Planning Application F/22/93835

**Demolition of all existing buildings and detailed planning approval for light industrial floorspace [Use Class E(g)(ii) & E(g)(iii)], warehouse floorspace [Use Class B8] and estate office (Use Class E(g)(i)).
MOORLANDS FARM, BOTLEY ROAD, WEST END, SOUTHAMPTON, SO30 3HD**

This Highway Technical Note Addendum has been produced in response to comments made by Hampshire County Council (HCC) and National Highways (NH) on the above planning application in their formal consultation dated 13th October and 25th October 2022 respectively.

CROSS SECTIONAL VISIBILITY

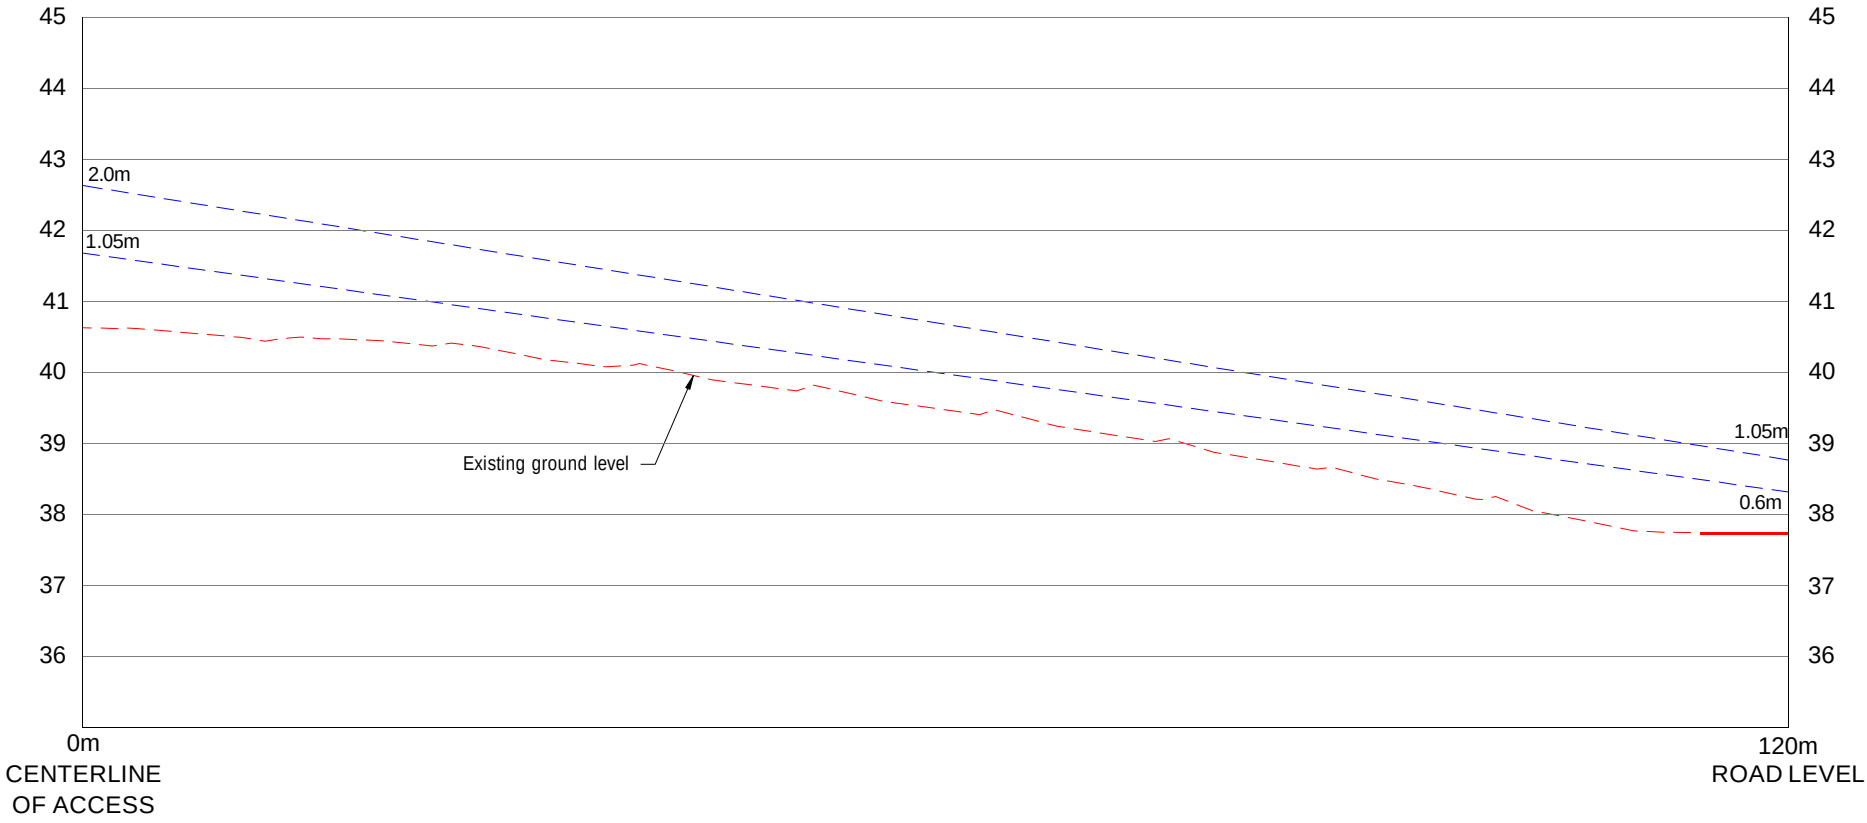
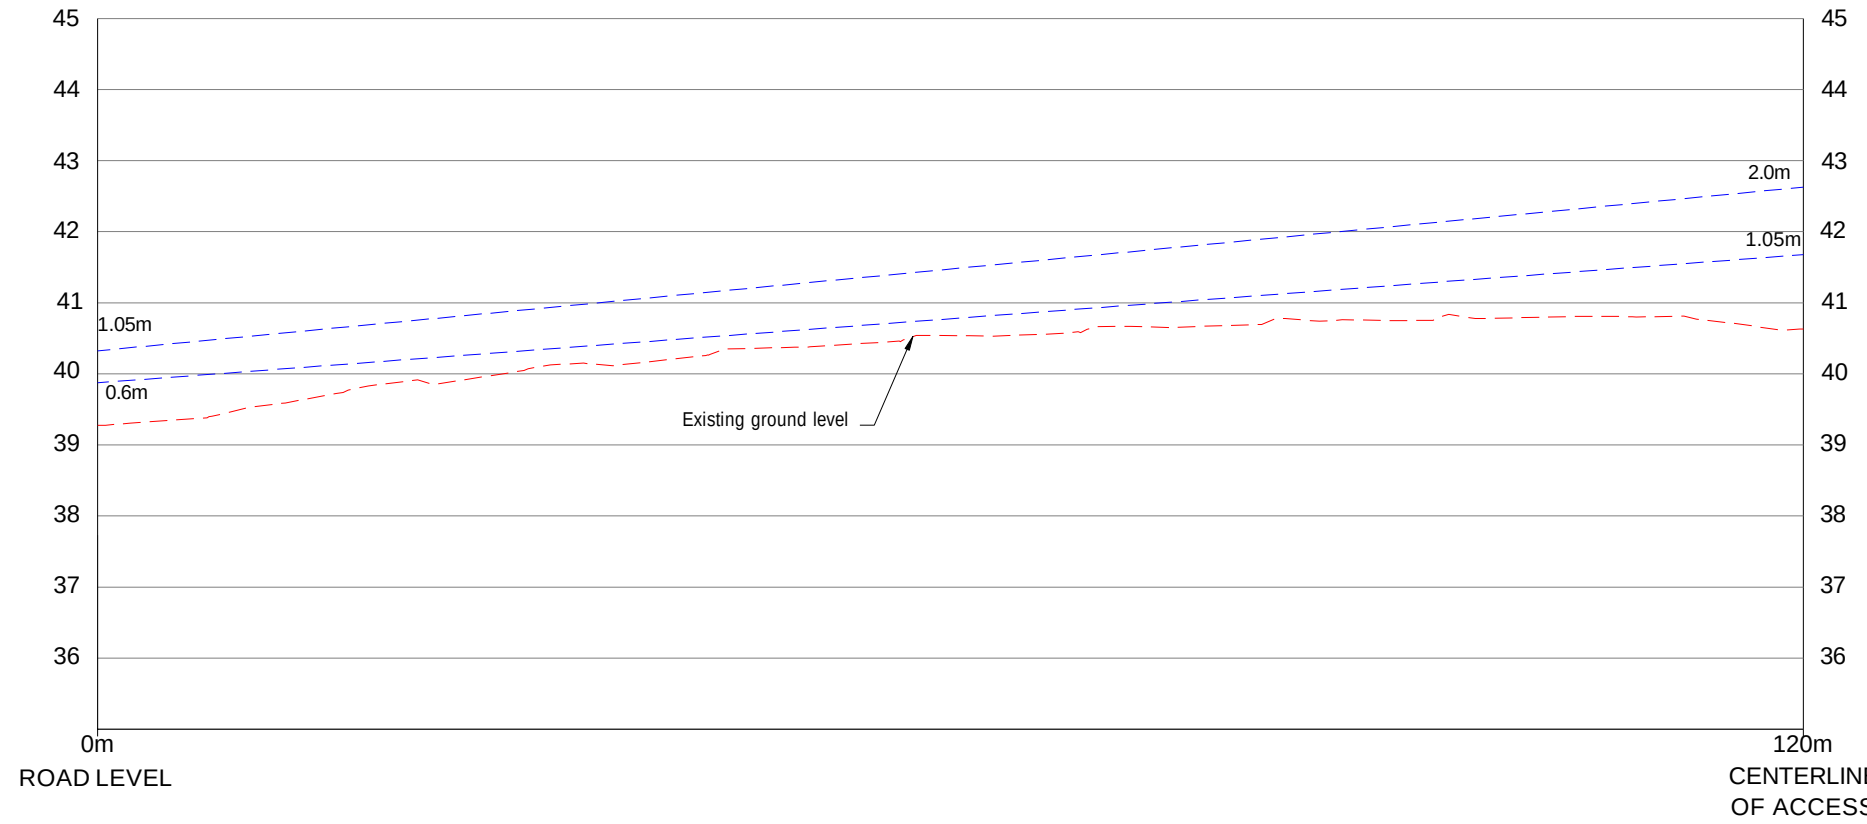
Taking the visibility issue first, whilst accepting the available visibility for the previous application which generated greater traffic movements, HCC have now questioned whether the splays can be physically achieved due to a fall in levels to the west and the brow of the hill, in this direction.

Drawing numbered NJC-007 is included as [Appendix 1](#) to this Note which shows a cross section through Botley Road at the point of the existing access. The drawing shows the ability of a driver to see from an eye height of between 1.05m and 2.0m to an object height of between 600mm and 1.05m. It is evident that the levels and the brow of the hill do not affect the ability for appropriate visibility to be achieved.

ACCESS AND TRACKING

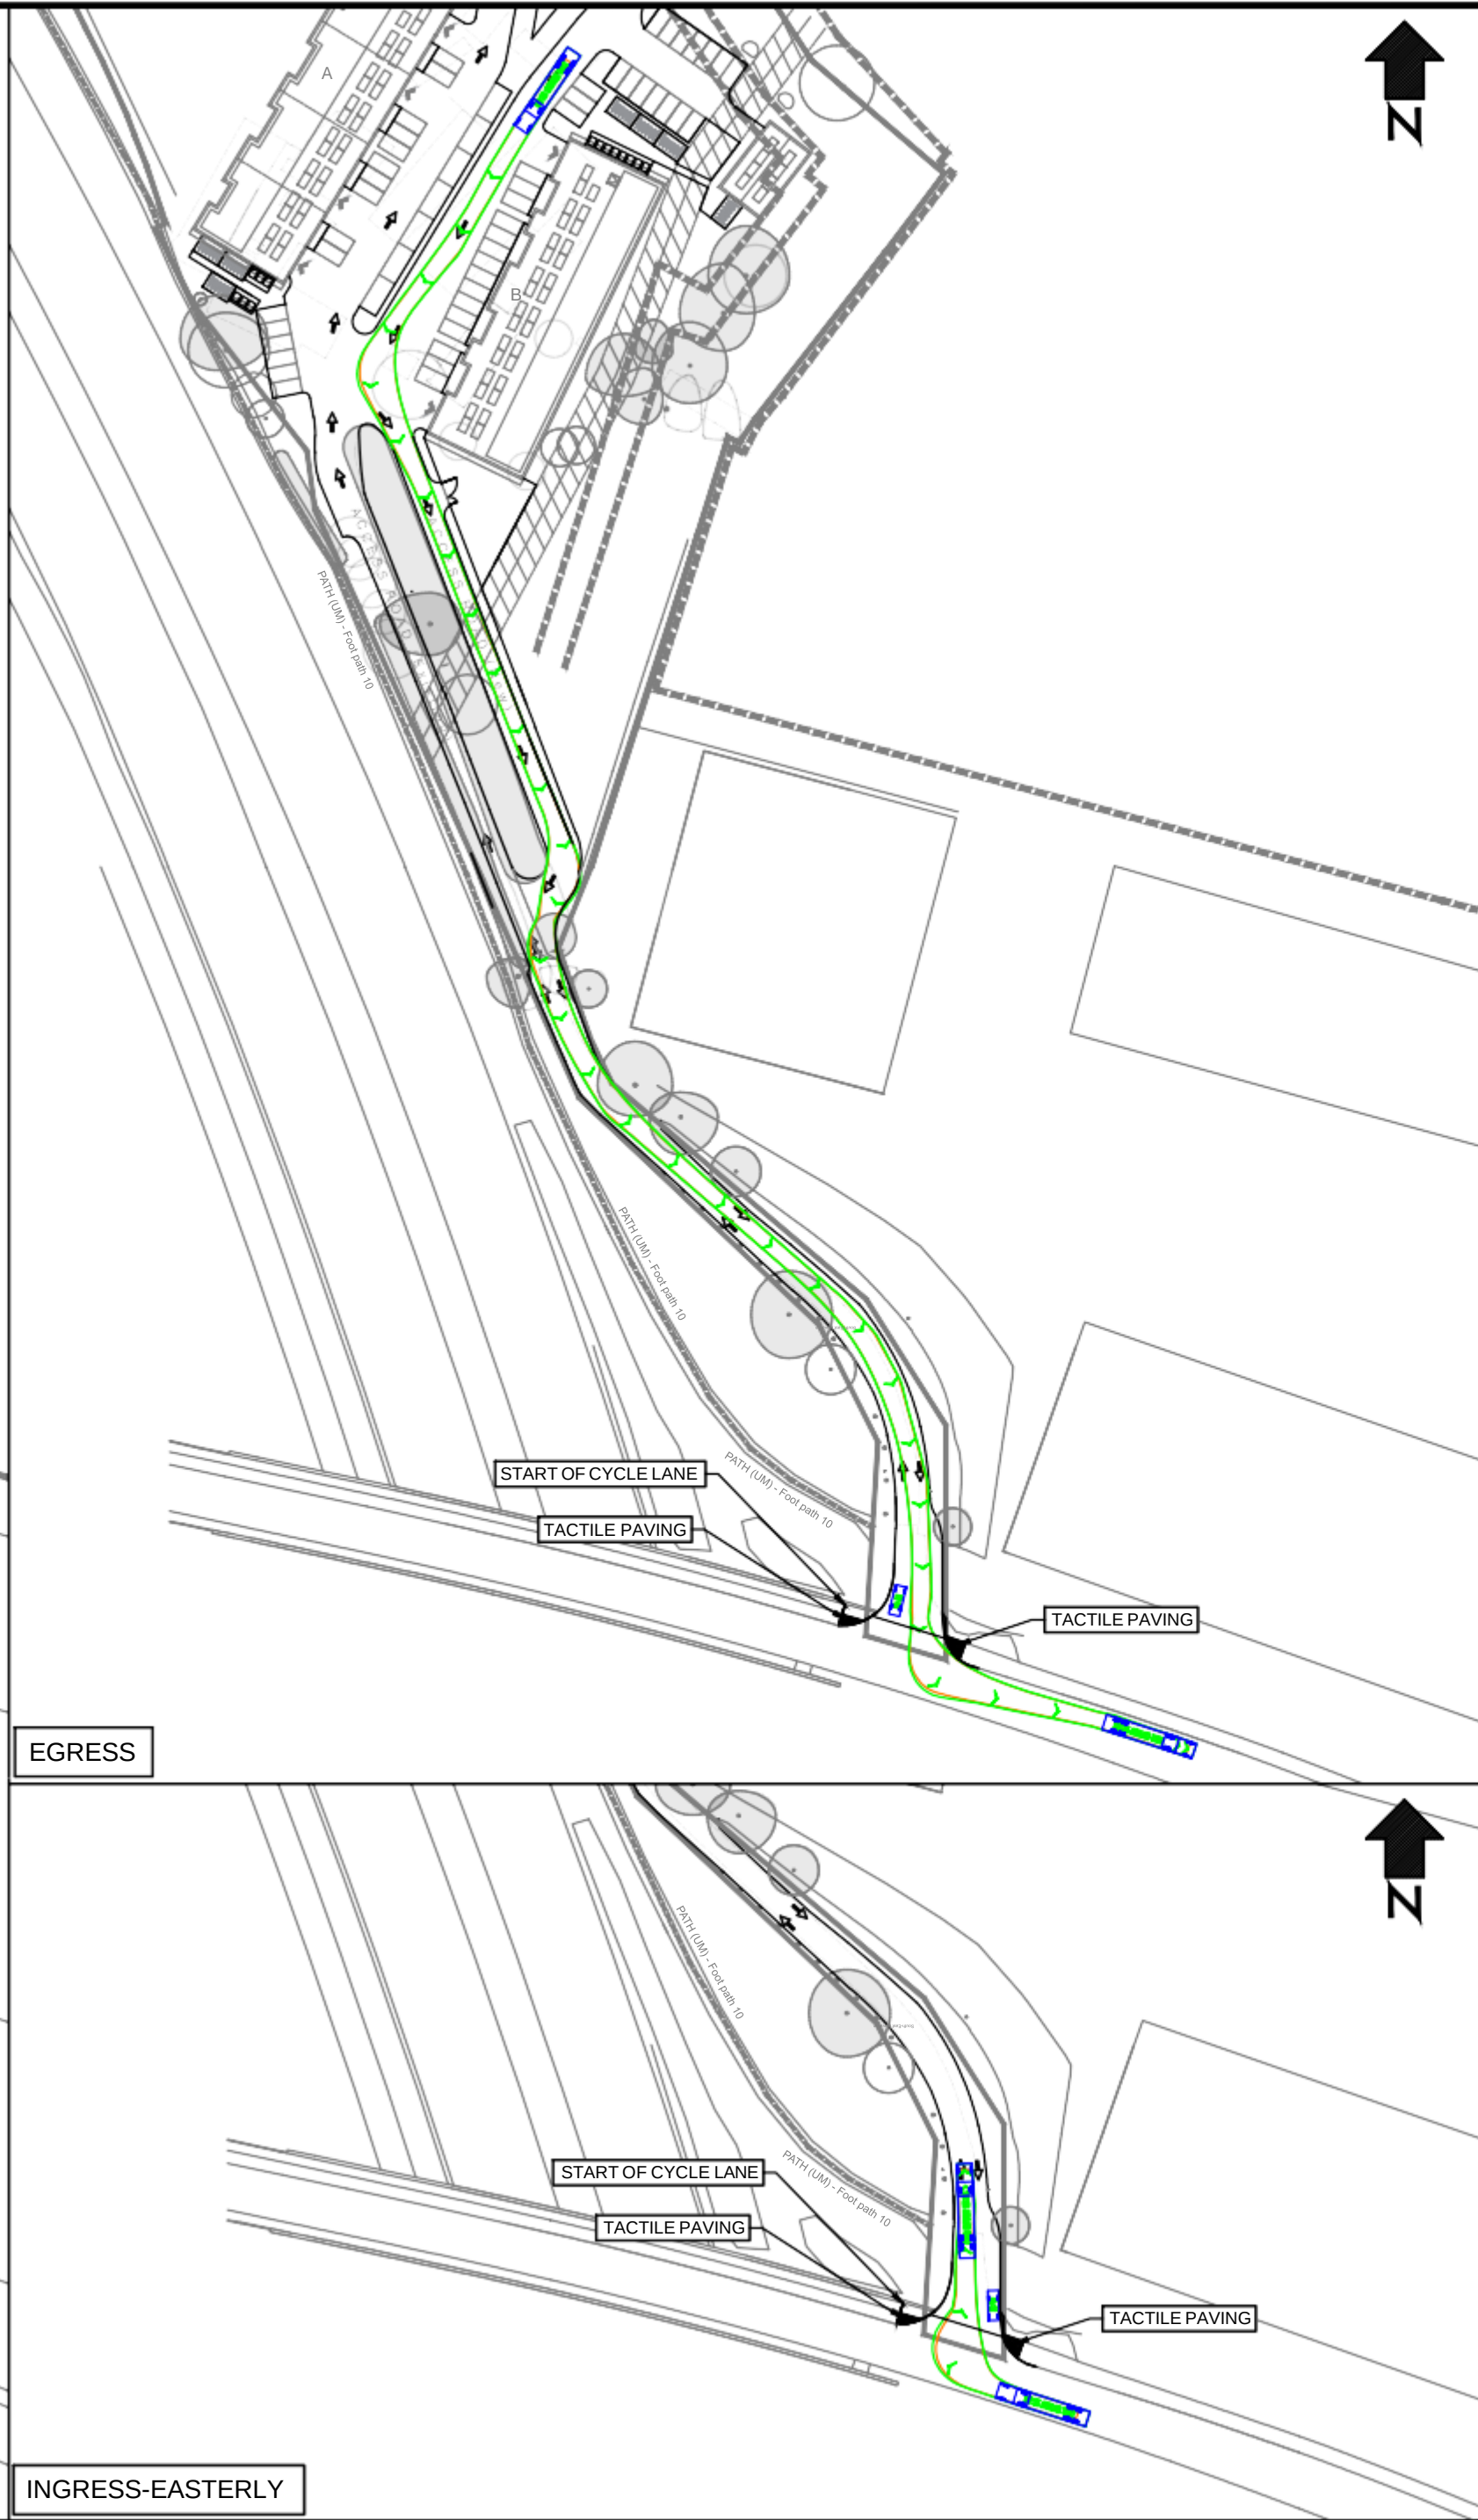
Concern was raised as to the increased use of the existing footway crossing, and potential conflicts with pedestrian and cyclists. Drawing numbered NJC-008 is therefore included as [Appendix 2](#) to this Note which shows the access now redesigned as a formal bell-mouth junction with tactile paving, to aid pedestrians at this point. The drawing demonstrates the principle of the proposal, although a more detailed design including construction details can be formulated as part of a formal Section 278 submission.

The access junction with the Botley Road has been designed to allow for a vehicle and an articulated lorry to pass one another at this point and this is demonstrated on drawing numbered NJC-010. Vehicles will not have to reverse out onto the Botley Road, therefore there will be no endangerment to pedestrians or cyclists using this section of Botley Road. The introduction of the Bellmouth junction with tactile paved dropped crossings will also enhance pedestrian safety at this point.
